DATE:	September 22, 2014	**PROJECT NO.:**	20140151
TO:	Mr. Jim Williams, City Manager		
FROM:	Brent Lacy, AICP, Dir., Transportation Planning		
CC:	Mr. Verl Emrick, George Kramer, AICP Dir. Planning, John Jones, Project Manager		
SUBJECT:	Maitland City Centre – Conceptual Parking Garage Plan Review

Maitland City Centre Garage

MAITLAND CITY CENTRE-STREET CROSS SECTIONS
CONCEPTUAL TECHNICAL DRAWINGS
GROUND LEVEL
1" = 40'-0"

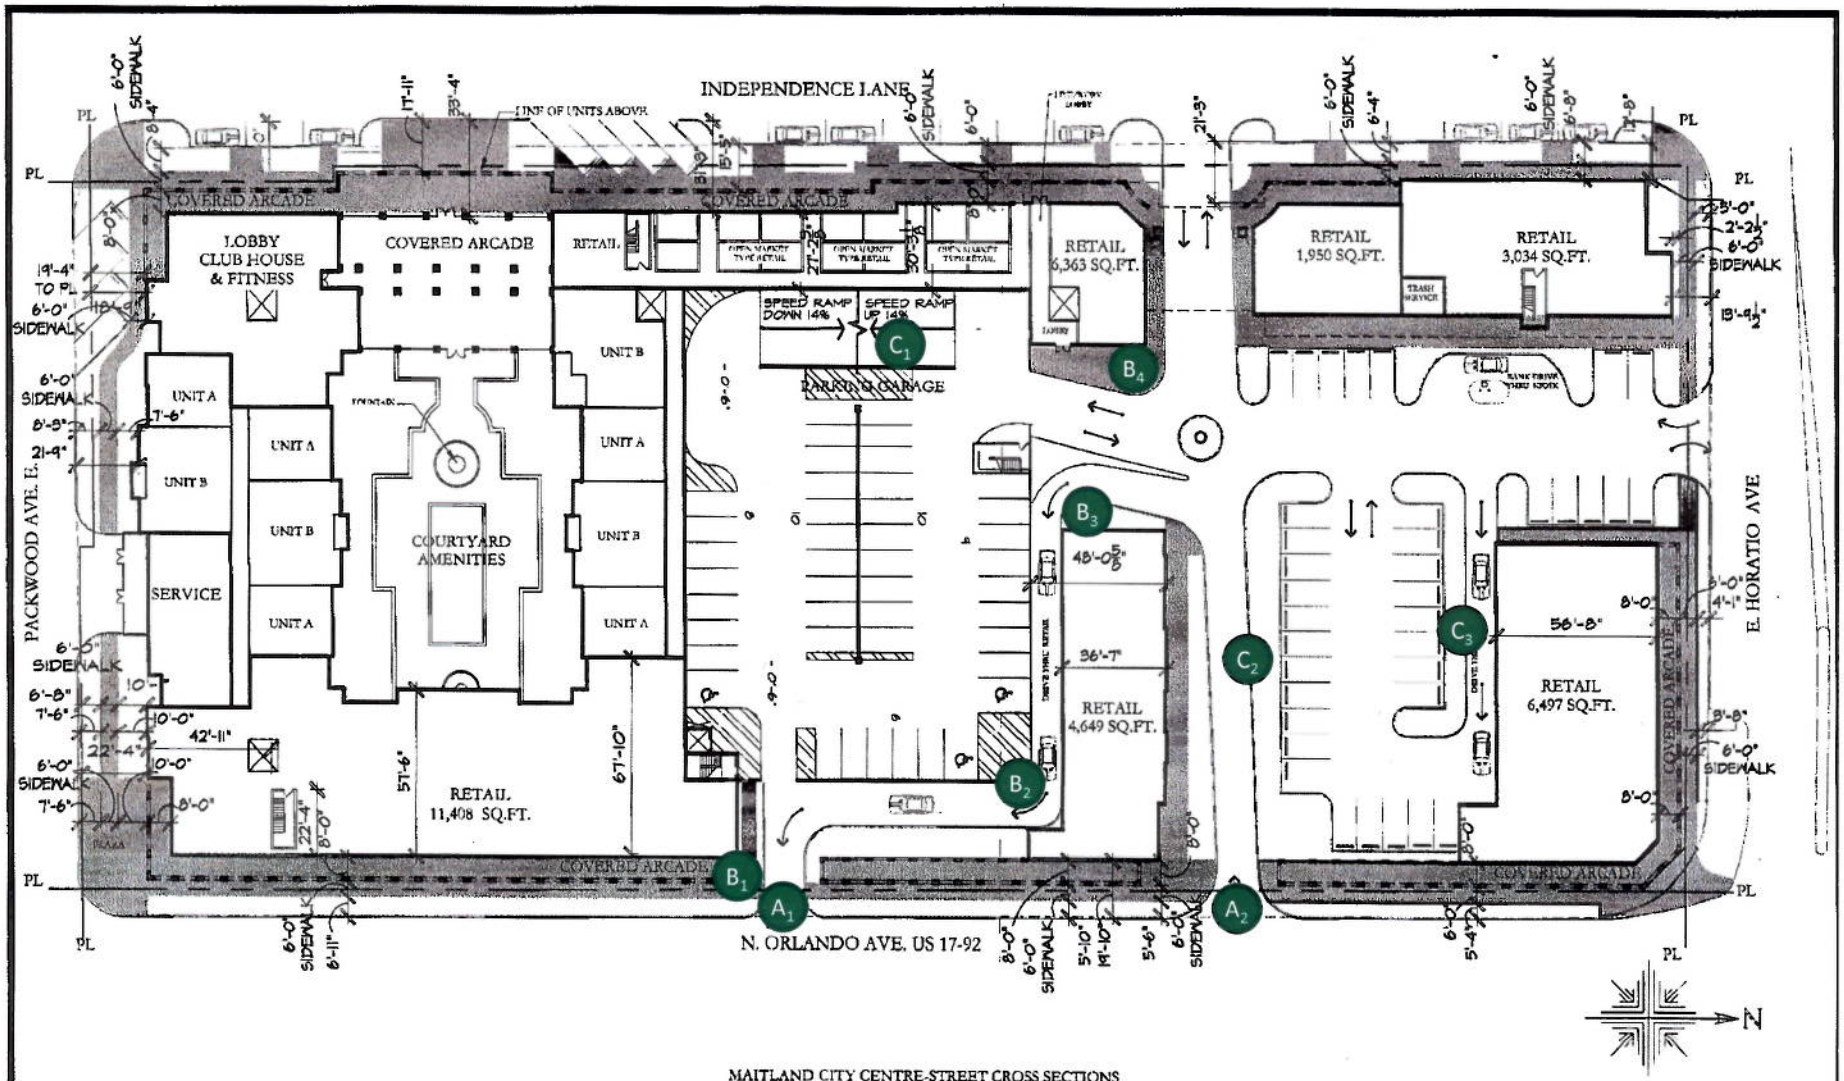
Access management rules will apply for the connections to US 17-92 (see attached Figure locations A1 & A2), a US Highway and under FDOT jurisdiction. The spacing on US 17-92 for the right-in and right-out driveway design and the sight distance requirements were reviewed. The findings regarding the concept plan were as follows:

1. The spacing appears to meet the FDOT requirements and the elimination of the multiple curb cuts that exist while replacing them with just the two connection drives will serve to reduce conflict points on US 17-92, thus improving the risk factors for crashes.
2. The final design should include analyses for sight distance criteria using the posted speed on US 17-92 to develop the "sight triangle" for the exit drive. All landscape and streetscape materials should be placed outside of this triangle to maintain a clear line of vision to the north for the existing vehicles.
3. The combined pair of one-way exit drives prior to the actual connection to US 17-92 should be reviewed and proper stop control and use of driveway mirrors to reduce the risk of on-site collisions should be considered. An open garage wall at this location along the east ground floor

of the garage should be evaluated and included to provide a "line of sight" for vehicles exiting from the interior of the garage.

B1, B3 & B4
The curb radius at these locations appears to be less than desirable and will create difficulty in maneuvering within and exiting the garage. A minimum of a 20-foot radius should be applied at these locations with 25-foot desirable.

B2
The design of the garage and the near 90-degree turn as shown is extremely constrained and will introduce the potential for wall and car damage from miscalculated turns. The circulation isle should be expanded and the 20-foot minimum turning radius applied here or the garage corner pulled back to provide a proper width for the turn.

1. By expanding the width of the garage (north-south axis) the ramp slope/grade could be reduced from 14% as shown to a grade closer to 10 % which is desirable.
2. The expansion of the garage and the retail units on the ground floor along the north wall could be accommodated up to 3 feet it appears by reducing the parking canoes (C2 and C3) and making a minor shift in the access drive location (A2). The skew created at the internal intersection should not be so significant as to present an issue.

1. Modify all corner curbs to reflect a minimum of a 20-foot radius
2. Evaluate and design the access drives to/from US 17-92 to meet all sight distance requirements
3. Consider modifications to the plan that will reduce the speed ramp grade from 14% to a point nearer 10 %, and most importantly
4. Modify the design of the plan to eliminate the turning movement constraints at the NW corner of the garage indicated on the attached figure at B2.
